Figures and Text Withheld Under 10 CFR 2.390

Chapter 1 General Information

Figure 3-31
Typical Clad and Pellet Dimensions As A Function of Exposure

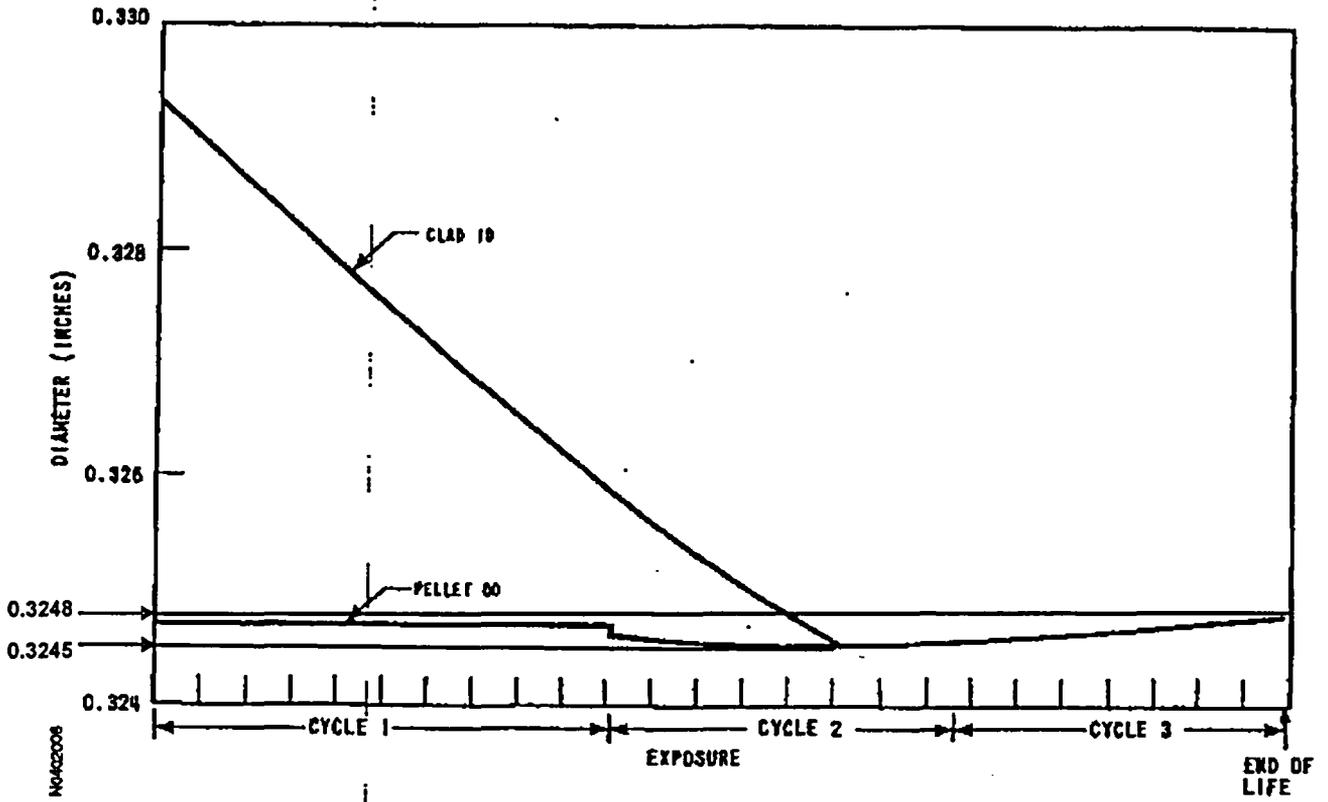
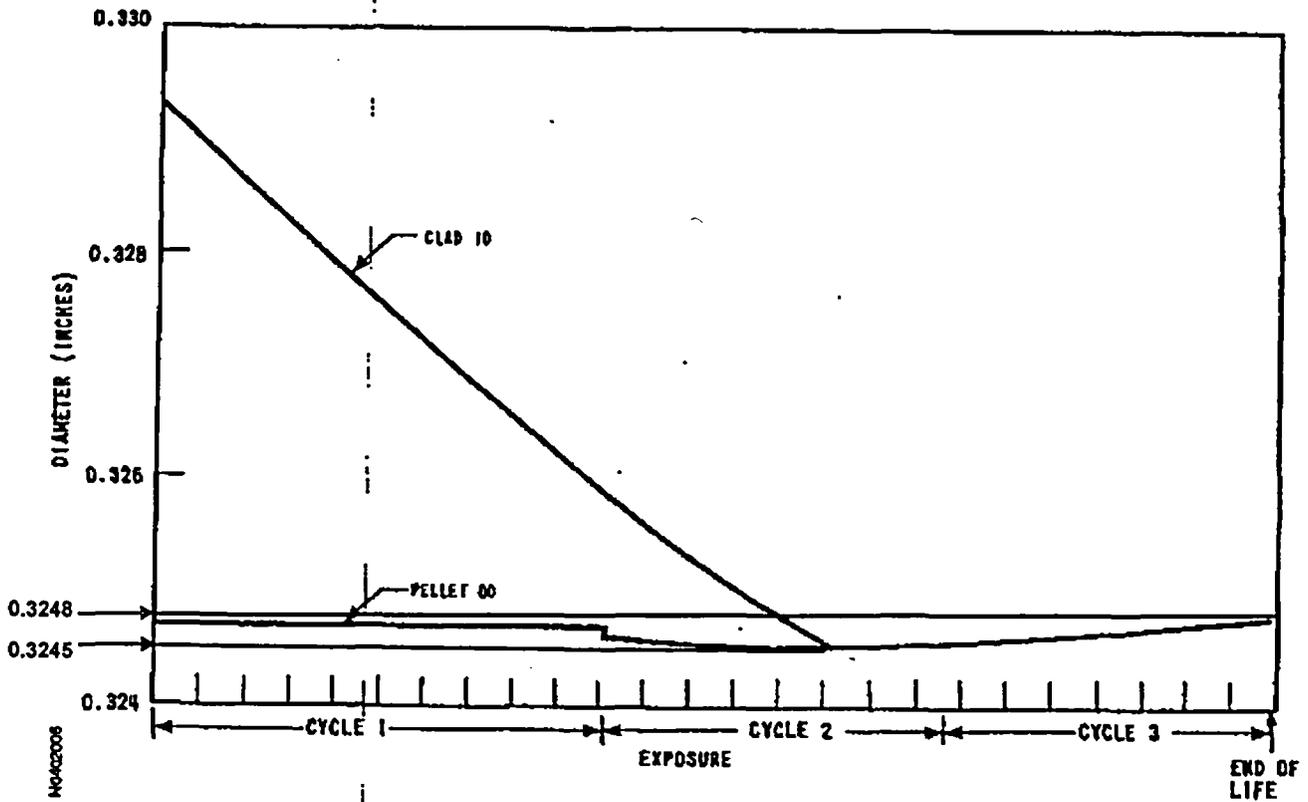
The application stated that: "Where it is conservatively assumed that the net tube MI is equal to one half of the total tube MI, and the net fuel MI is equal to one half of the total fuel MI The basis to include fuel MI in the stress calculation is not conservative and subject to challenge. Please provide the justification for the assumption.

Typical cladding and fuel pellet dimensions as a function of exposure [3-11] are shown on Figure 3-31 of this RAI for information. This figure shows that during operation, the cladding ID will gradually reduce and touch the pellet OD during operation cycle 2 (ID of cladding = OD of pellet = 0.3245"). In starting cycle 3, the pellet and clad ID will expand as a unified piece through the remaining cycle life (OD of pellet = 0.3248").

Figure 3-40
Effect of Tempering Temperature on Notch Toughness

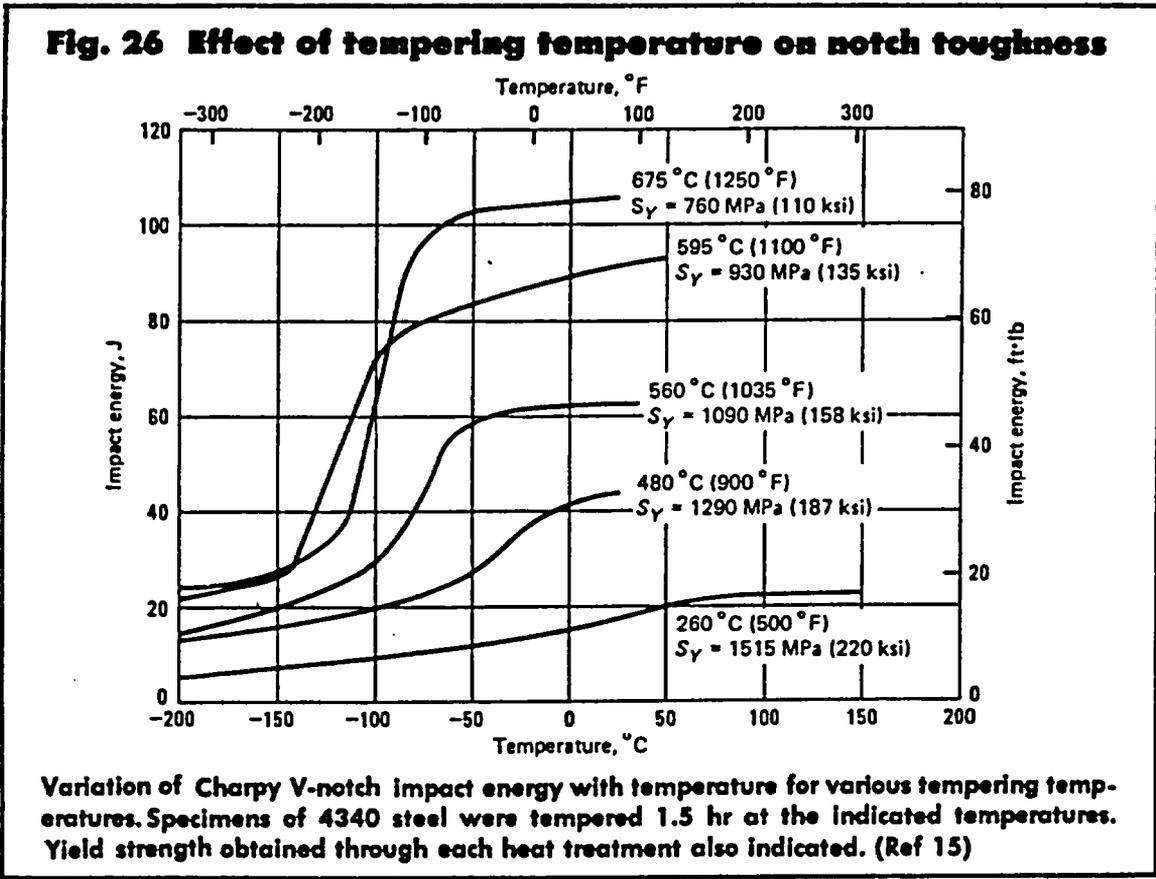
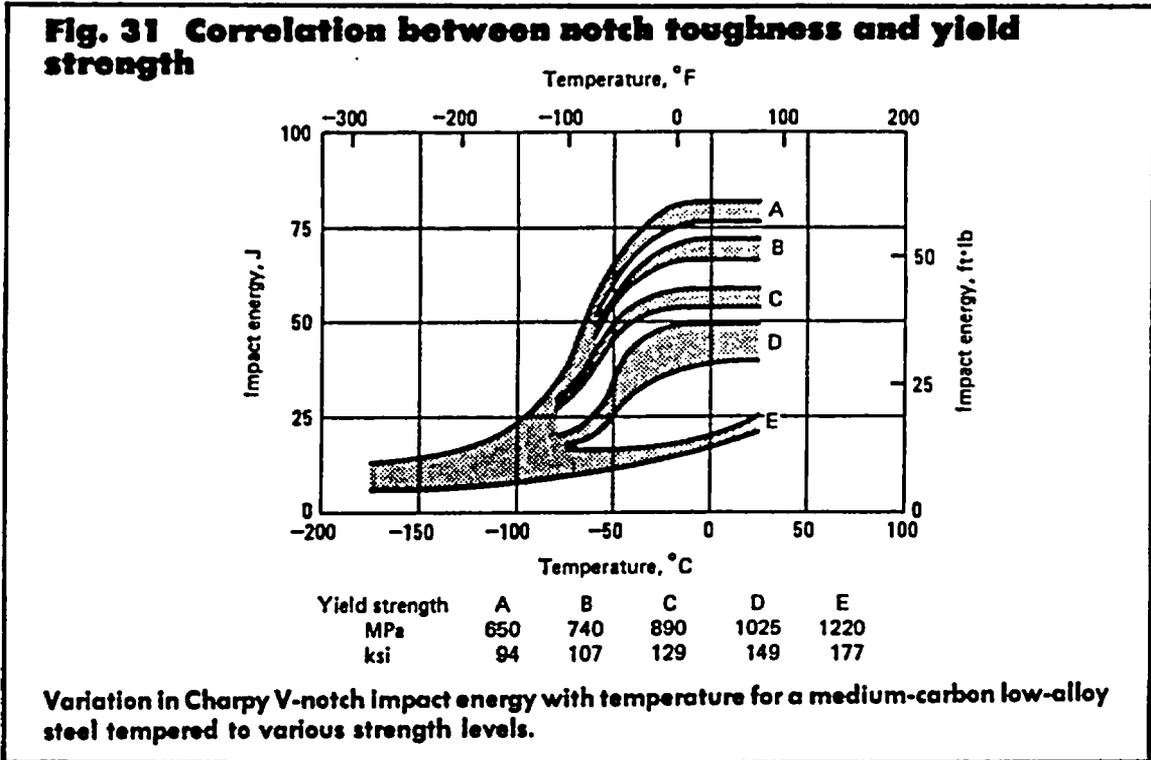
3-16 Provide a brittle fracture analysis to evaluate the fracture toughness of the transfer cask bolts,

ASM Metal Handbook (Volume 1) [3-18], Figure 26 (reproduced here in Figure 3-40) shows that a 4340 steel tempered at 1035°F for 1 ½ hours to produce a yield strength of 158 ksi exhibits a very low Charpy impact transition temperature (< -20°F) and an upper shelf energy of about 45 ft-lbs at -20°F.

Figure 31 (reproduced here in Figure 3-41) shows that a medium carbon low alloy steel tempered to a yield strength of 107 ksi (like SA-197, Grade B7) would have an upper shelf energy of about 52 ft-lbs and absorb about 48 ft-lbs at -20°F while material at a yield strength of 149 ksi (like SA-540 Gr. B24 Cl. 1) would have an upper shelf energy of 35 ft-lbs and absorb about 30 ft-lbs at -20°F.

Figure 3-43
Temperature Vs Tensile and Yield Strength for Low Burnup Fuel

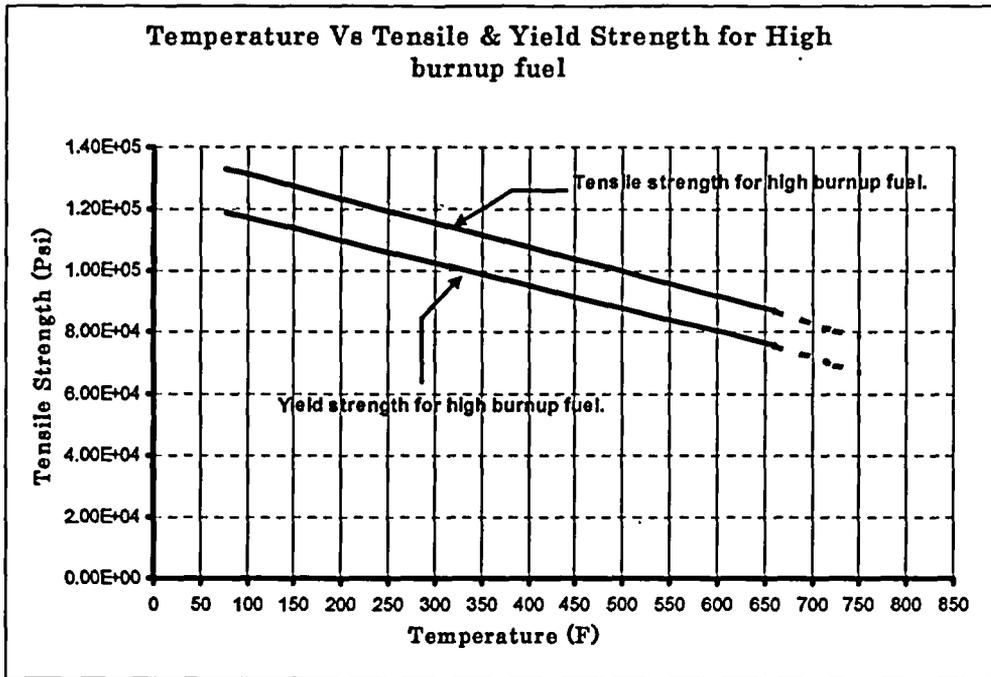
- 3-17 Provide correct irradiated material properties; in particular, the ultimate strength, yield strength, and oxide thickness used for the fuel rod integrity during drop scenario at 750°F. Additionally, show that they are bounding for the irradiated fuel type chosen for the analysis. Further, clarify if an extrapolation was done to obtain the mechanical properties at 750°F, and if so, provide the calculations to obtain the mechanical properties.**

Yield Strength of cladding: The yield stress vs. temperature is taken from Table 5 of [3-13, page 12] and is depicted in Figure 3-43. Since the relation between the yield strength vs. temperature is linear, the yield strength at higher temperature is obtained by extending the curve.

Tensile Strength of cladding: The tensile strength corresponding to the yield strength at the temperatures is obtained from Figure 5 of [3-13, page 17] and is also depicted in
